**PCN#20200526001.1  
New Tray for Select QFP Devices  
Final Change Notification**

<b>PCN Number:</b>	20200526001.1		<b>PCN Date:</b>	June 8, 2020	
<b>Title:</b>	New Tray for Select QFP Devices				
<b>Customer Contact:</b>	PCN Manager	<b>Dept:</b>	Quality Services		
<b>Proposed 1<sup>st</sup> Ship Date:</b>	Sept. 8, 2020				
<b>Change Type:</b>					
<input type="checkbox"/>	Assembly Site	<input type="checkbox"/>	Design	<input type="checkbox"/>	Wafer Bump Site
<input type="checkbox"/>	Assembly Process	<input type="checkbox"/>	Data Sheet	<input type="checkbox"/>	Wafer Bump Material
<input type="checkbox"/>	Assembly Materials	<input type="checkbox"/>	Part number change	<input type="checkbox"/>	Wafer Bump Process
<input type="checkbox"/>	Mechanical Specification	<input type="checkbox"/>	Test Site	<input type="checkbox"/>	Wafer Fab Site
<input checked="" type="checkbox"/>	Packing/Shipping/Labeling	<input type="checkbox"/>	Test Process	<input type="checkbox"/>	Wafer Fab Materials

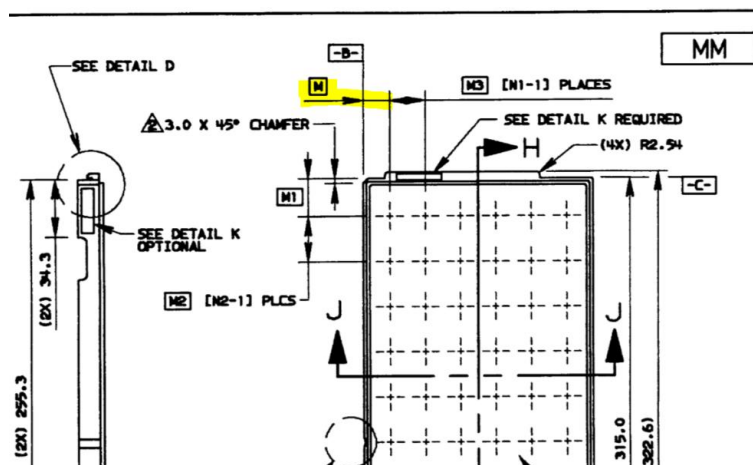
Texas Instruments is pleased to announce the qualification of a new tray for the devices listed below. A comparison summary of the tray differences as follows:

4221057-0001	4224858-0001
Supplier	UBOT	Peak
Floor design	Circular square	Octagon
Pitch M	15.45	15.40
Cavity size (TOP and BOTTOM)	16.30 +/- 0.1 14.60 +/- 0.1	16.25 +/- 0.08 14.20 +/- 0.08
Seating ht (TOP and BOTTOM)	1.70 +/- 0.08 1.07 +/- 0.08	1.70 +/- 0.1 1.10 +/- 0.1

New tray eliminate tray warpage and unit stuck up

## Device Fit Analysis:

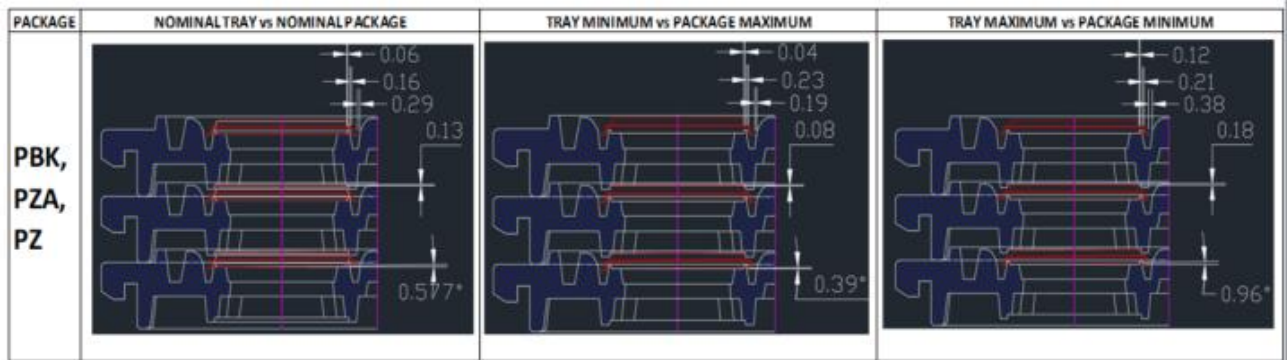
- X and Y clearance is not greater than 0.5 mm
- Rotation is less than 10 degrees
